### UN Regulation No. 166 (Close-Proximity to the Front and Lateral Sides of Vehicles)

#### **Proposal for 01 series of amendments to UN Regulation No. 166 (Driver's Awareness of Vulnerable Road Users in Close-Proximity to the Front and Lateral Sides of Vehicles)**

#### **Submitted by the expert of the Informal Working Group on Awareness of Vulnerable Road Users Proximity (VRU-Proxi)**

Figure 1  
Example for the measurement by maximum variation

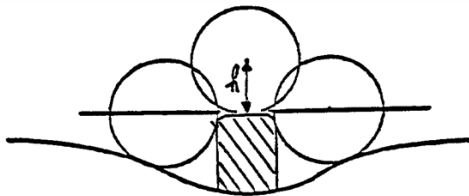
- 6.1.3.3.2. If the dimension of the projection of a component which is mounted on a surface other than convex cannot be determined by simple measurement, it shall be determined by the maximum variation of the distance of the centre of a 100 mm diameter sphere from the nominal line of the panel when the sphere is moved over and is in constant contact with that component.

Figure 1 shows an example of the use of this procedure.

Addition of impact safety requirements for mirrors copied from the UN regulation No.46 and exempt the devices approved by UN regulation No.26 or No.61.

Figure 2

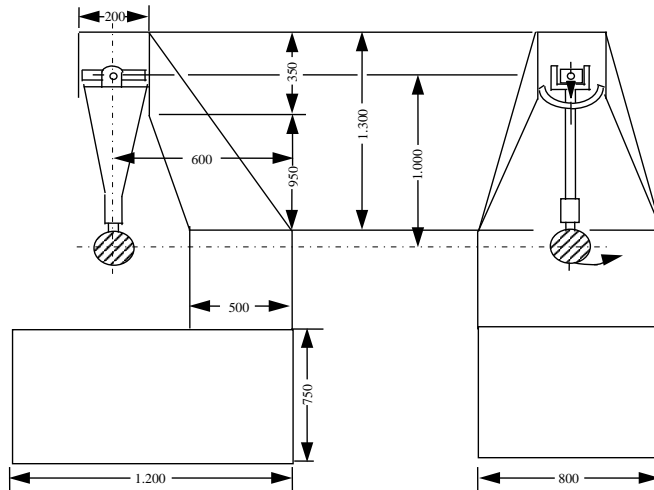
Figure 2 below gives the dimensions (in mm) of the test rig and the special design specifications:

6.2.2.1.2. The centre of percussion of the pendulum coincides with the centre of the sphere, which forms the hammer. It is at a distance  $l$  from the axis of oscillation in the release plane, which is equal to  $1\text{ m} \pm 5\text{ mm}$ . The reduced mass of the pendulum is  $m_o = 6.8 \pm 0.05$  kilograms. The relationship of  $m_o$  to the total mass  $m$  of the pendulum and to the distance  $d$  between the centre of gravity of the pendulum and its axis of rotation is expressed in the equation:

**Figure 3**

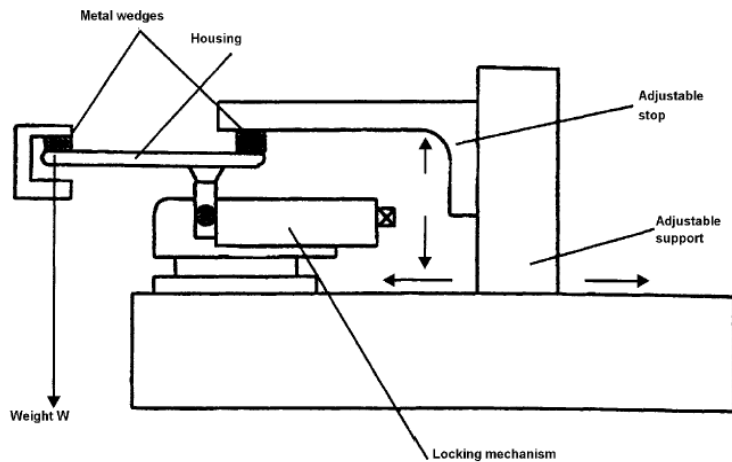
The protective housing is placed horizontally in a device in such a way that it is possible to lock the attachment support adjusters firmly. In the direction of the largest dimension of the housing, the end closest to the point of attachment on the adjuster for the support shall be immobilized by a 15 mm-wide rigid stop covering the entire width of the housing.

At the other end, a stop identical to the one described above is placed on the housing so that the specified test load can be applied to it (Figure 3).

The end of the housing opposite to that where the force is exerted may be locked rather than held in position as shown in Figure 3.

6.2.2.3.2. The test loading shall be 25 kilograms and shall be maintained for one minute.

**Figure 5**

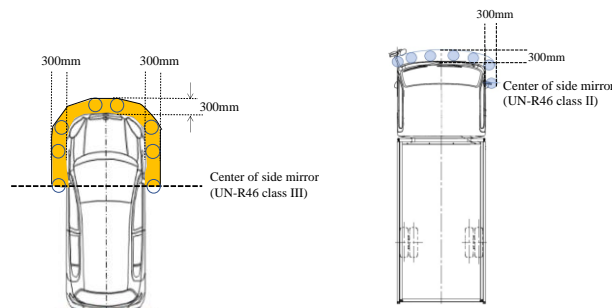
Paragraph 15.2., amend and delete Figure 2, to read:

The field of vision (see Figure 2 5 below) shall be bounded by the following planes:

- (a) A **longitudinal** ~~transverse~~ vertical plane passing through a point 300 mm from the contour of the sides of the vehicle;
- (b) A transverse **vertical** ~~horizontal~~ plane passing through a point 300 mm from the contour of the front of the vehicle;
- (c) Areas ahead of the centre of the side mirrors on the driver's seat side and the passenger seat side. In the case of the vehicle that equipped with CMS that comply UN Regulation No. 46, 04 Series of amendments, the manufacturer shall consider the same vehicle equipped with side mirrors or to use the centre of Class III or II CMS camera lens instead of the centre of the side mirrors.

The contour shall be defined by the vehicle outside shape projection to the ground that can place the test object defined in Annex 9 of this Regulation (300mm diameter pole). Small outside shape irregularity is not included.

Reorganized between two paragraphs 15.1 and 15.2 for misunderstanding and clear descriptions. Figures were updated about pole location at center of side mirror for misinterpretation.

Figure 6  
Example for the measurement by maximum variation

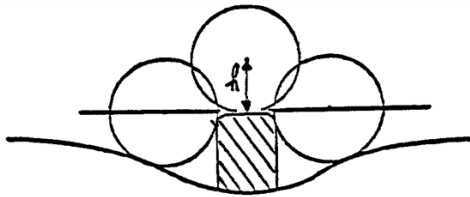
- 15.4.3.3.2. If the dimension of the projection of a component which is mounted on a surface other than convex cannot be determined by simple measurement, it shall be determined by the maximum variation of the distance of the centre of a 100 mm diameter sphere from the nominal line of the panel when the sphere is moved over and is in constant contact with that component.  
Figure 6 shows an example of the use of this procedure.

Addition of impact safety requirements for FLVCS and Detection system same as mirror (6.1.3.).

“Figure 2  
Test Object Locations

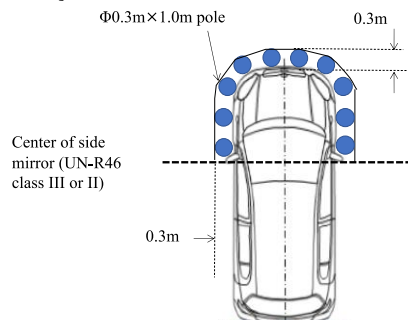
Replace Annex 9 Paragraphs 1.2. Figure 2, to read:

Add the rescription for Class II mirror in the figure.
